CITY OF ALBUQUERQUE

Re: Stanford Court
424 Stanford Dr., SE
Traffic Circulation Layout
Engineer's/Architect's Stamp 3-2-16 (K16-D084)

Based upon the information provided in your submittal received 3-29-16, the above referenced plan cannot be approved for Building Permit until the following comments are addressed:

Figure 1. Mini Clear Sight Triangle

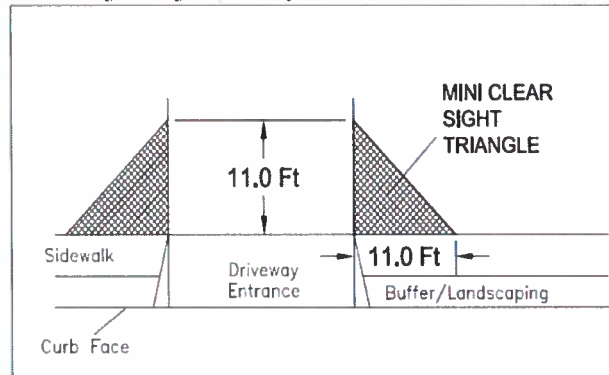
11. Please provide a Mini Clear Sight distance exhibit (see the *Development Process Manual, Chapter 23, Section 3*), for the entrance/exit off of the public alley on the east side of the project site.

12. Please add the following note to the clear sight triangle: "Landscaping and signage will not interfere with clear sight requirements. Therefore, signs, walls, trees, and shrubbery between 3 and 8 feet tall (as measured from the gutter pan) will not be acceptable in this area."
13. All broken or cracked sidewalk must be replaced with sidewalk and curb & gutter. A build note must be provided referring to the appropriate City Standard drawing.
14. Please include two copies of the traffic circulation layout at the next submittal.
